VIRGINIA ELECTRIC AND POWER COMPANY

August 27, 2001

VIRGINIA ELECTRIC AND POWER COMPANY
NORTH ANNA POWER STATION UNITS 1 AND 2
PROPOSED IMPROVED TECHNICAL SPECIFICATIONS
REQUEST FOR ADDITIONAL INFORMATION – SPECIFICATION 3.3.1

North Anna Improved Technical Specifications (ITS) Review Comments
ITS Section 3.3, Instrumentation
LCO 3.3.1, RTS Instrumentation

3/4 3-4a
page 5 of 20

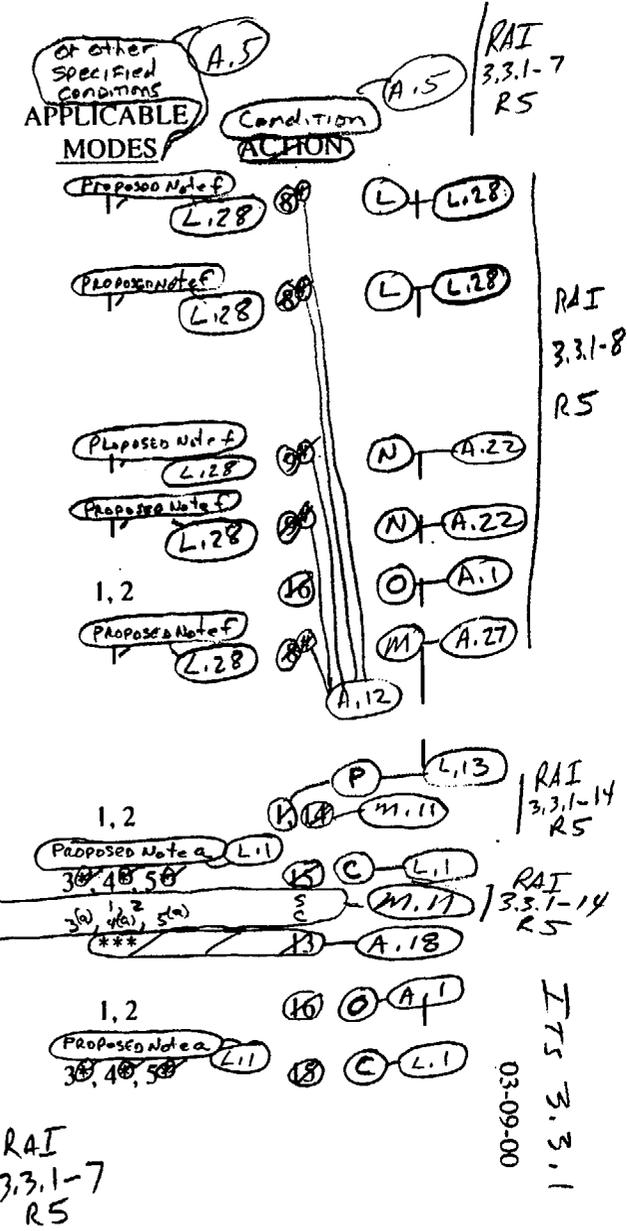
Comment #1 - Add DOC A.5 discussion for items labeled in Table 4.3-1 as DOC A.5 changes.

Comment #2 - The changes cited and discussed in the paragraph above are consistent with the use of LA changes Type 1 - removing details of system design and system description, including design limits.

Comment #3 - The changes cited and discussed above in the third sentence are consistent with the use of LA changes Type 1 - removing details of system design and system description, including design limits.

Response: The Company agrees with Comment 1. DOC A.5 has been revised to include the change to the CTS Table 4.3 – 1, and the CTS markup have been revised to clarify the changes that are discussed by DOC A.5.

The Company agrees with Comments 2 and 3. The deletion of the “CHANNELS TO TRIP” or the “MINIMUM CHANNELS OPERABLE,” columns are now addressed by DOC LA.15. DOC A.5 has been modified by deleting the discussion of these columns.

TABLE 3.3-1 (CONTINUED)
REACTOR TRIP SYSTEM INSTRUMENTATION

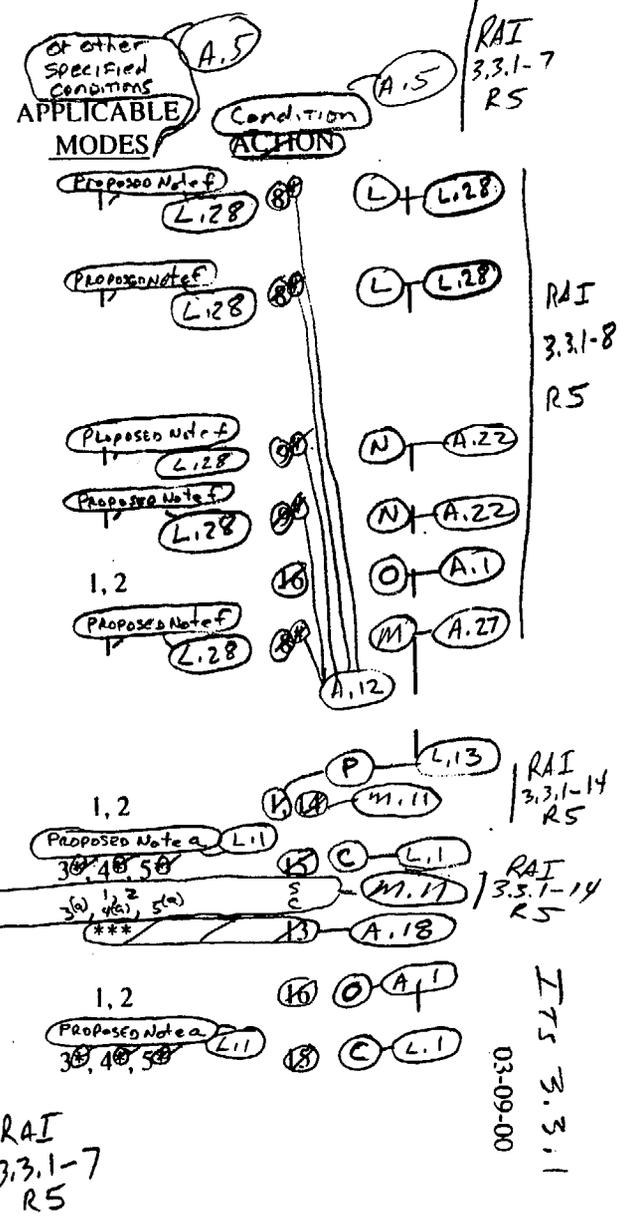
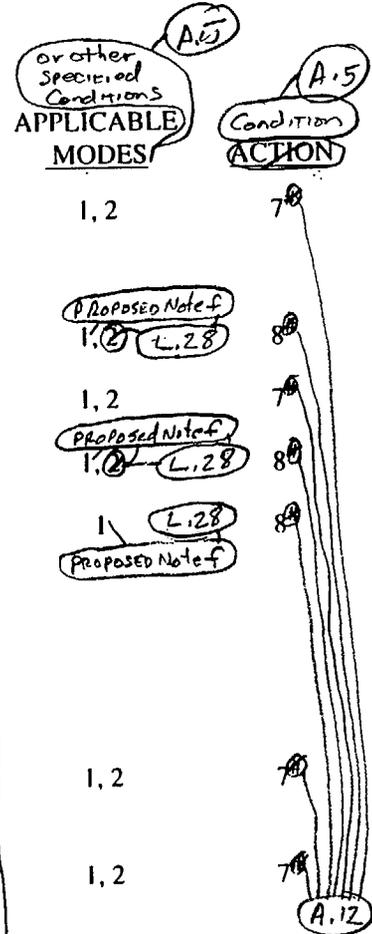
Comment#1 - Proposed changes to CTS Applicabilities represent less restrictive changes to the plant licensing basis because the ITS requires that the functions be operable in Mode 1 above P-7 (10% RTP) whereas, CTS require the same functions to be operable in Mode 1 (> 5% RTP) or Modes 1 and 2 (\geq 5% RTP). These less restrictive changes are not evaluated in the DOCs.

Comment#2 - ITS function 11 (Reactor Coolant Pump Breaker Position) Applicability changes are not discussed in DOC A.9.

Comment#3 - ITS function 20 (RCP Breaker Position) is referenced in the DOC but changes not listed in the ITS references. Also, the CTS requires total channels to be 1/breaker whereas, the ITS requires 1/RCP. This change is not evaluated in a DOC.

Response: The Company agrees with Comment 1. DOC A.9 has been eliminated and DOC L.28 is added to address the change in applicability.

The Company agrees with Comment 2. ITS function 11 has been added to DOC L.28.

The Company agrees with Comment 3. CTS is changed to delete 1/breaker and add 1/RCP with DOC A.27 modified to include the change.
